# Access Compliance Report

## Public Rights-of-Way

### (Curb Ramps)

Intersection ID: 17042	Main Street: BUCKNELL_AV	Cross Street: QUEENS_RD_EAST	Location: E
ADA ID: 4A47A604E91B	Ramp Type: Directional1	Initial Pass/Fail: Fail	Overall Compliance: No
Severity Score: 13.75			
Codes/Mitigation Info/Possible Solution		Field Measurements/Component Compliance

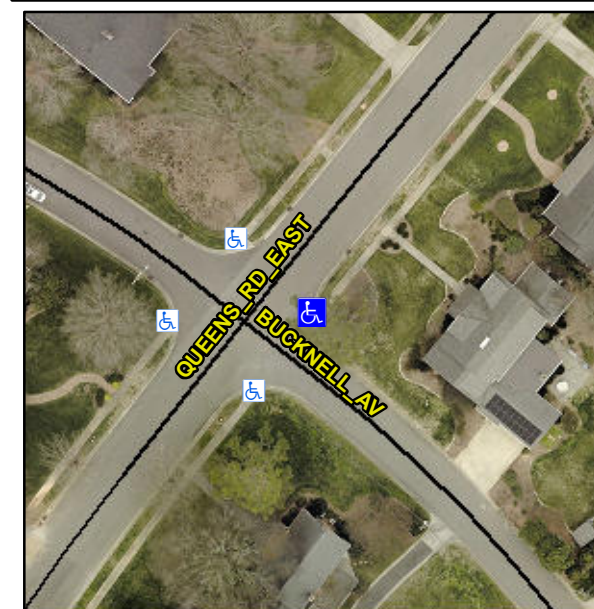
**R304.2.2, R304.5.3**

Compliance	Description	Data	Compliance	Description	Data
N/A	Ramp Length (in)	86.0	N/A	Grade Break?	N/A
Yes	Ramp Width (in)	48.0	N/A	Grade Break Slope (%)	0.0
No	Ramp Slope (%)	9.6	N/A	Grade Break XSlope (%)	0.0
No	Ramp XSlope (%)	2.6			
N/A	Flare Type LT	N/A	N/A	Flare Type RT	N/A
N/A	Flare Slope LT (%)	N/A	N/A	Flare Slope RT (%)	0.0
N/A	Flare Traversable LT?	N/A	N/A	Flare Traversable RT?	N/A
N/A	Landing Length (in)	0.0	N/A	DWS Provided?	N/A
N/A	Landing Width (in)	0.0	N/A	DWS Contrast?	N/A
N/A	Landing Slope (%)	0.0	N/A	DWS Length (in)	N/A
N/A	Landing X Slope (%)	0.0	N/A	DWS Full Width?	N/A
N/A	Landing Curb? (Y/N)	N/A	N/A	DWS Offset LT (in)	N/A
N/A	Shared Landing?	N/A	N/A	DWS Offset RT (in)	N/A
N/A	Gutter Ponding?	0.0	N/A	Gutter Slope (%)	N/A
N/A	Gutter Lip Ht (in)	0.0	N/A	Gutter X Slope (%)	N/A
N/A	Painted X Walk1?	No		Road Slope (%)	0.8
	X Walk 1 Direction	To SW		Road X Slope (%)	5.4
	X Walk 1 Width (in)	N/A		Clear Space?	N/A

X Walk 1 Slope (%)	0.8	N/A	Clear Space to XWalk (in)	N/A
	X Walk 1 X Slope (%)	5.4	N/A	Storm Grate/Utility Hazard?	N/A
N/A	Ramp inside XWalk1?	N/A		Storm Grate/Utility Type	
N/A	Any Obstructions?	N/A			N/A
	Obstruction Type		Yes	Surface Condition? (G/P)	Good
			N/A	Curb Slope (%)	27.5

**Remove & Replace Entire Ramp.**

\$ 1600.00
